Access Compliance Report

Public Rights-of-Way

Intersection ID: 23277	Main Street: S_TRYON_ST	Cross Street: JOHN_PRICE_RD	Location: NW
ADA ID: 7B934BA47A55	Ramp Type: Perp	Initial Pass/Fail: Pass	Overall Compliance: No
			Severity Score: 25.25

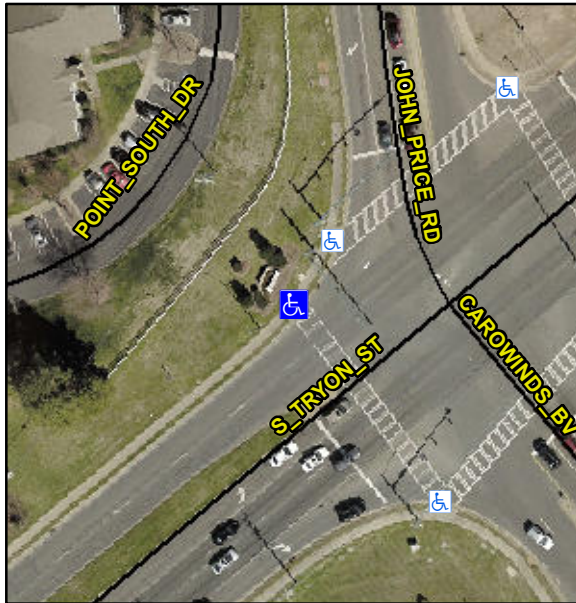
**R304.5.3, R304.2.1, R304.2.2-Perp,
R304.3.2-Para, R305.2, R302.7.2**

Compliance	Description	Data	Compliance	Description	Data
N/A	Ramp Length (in)	87.0	Yes	Ramp Slope (%)	7.9
Yes	Ramp Width (in)	48.0	No	Ramp XSlope (%)	3.3
N/A	Flare Type LT	Sloped	N/A	Flare Type RT	N/A
N/A	Flare Slope LT (%)	7.6	Yes	Flare Slope RT (%)	5.9
N/A	Flare Traversable LT?	Yes	N/A	Flare Traversable RT?	Yes
No	Landing Length (in)	N/A	Yes	DWS Provided?	Yes
No	Landing Width (in)	N/A	Yes	DWS Contrast?	Yes
No	Landing Slope (%)	N/A	Yes	DWS Length (in)	24.0
No	Landing X Slope (%)	N/A	Yes	DWS Full Width?	Yes
N/A	Landing Curb? (Y/N)	No	No	DWS Offset (in)	4.5
N/A	Shared Landing?	No			
Yes	Gutter Ponding?	No	Yes	Gutter Slope (%)	4.6
No	Gutter Lip Ht (in)	1.0	Yes	Gutter X Slope (%)	1.4
N/A	Painted X Walk1?	Yes	N/A	Painted X Walk2?	N/A
	X Walk 1 Direction	To SE		X Walk 2 Direction	N/A
N/A	X Walk 1 Width (in)	115.0	N/A	X Walk 2 Width (in)	N/A
	X Walk 1 Slope (%)	3.9		X Walk 2 Slope (%)	N/A
	X Walk 1 X Slope (%)	0.2		X Walk 2 X Slope (%)	N/A

**Remove & Replace Entire Ramp.
Grind Gutter Lip.**
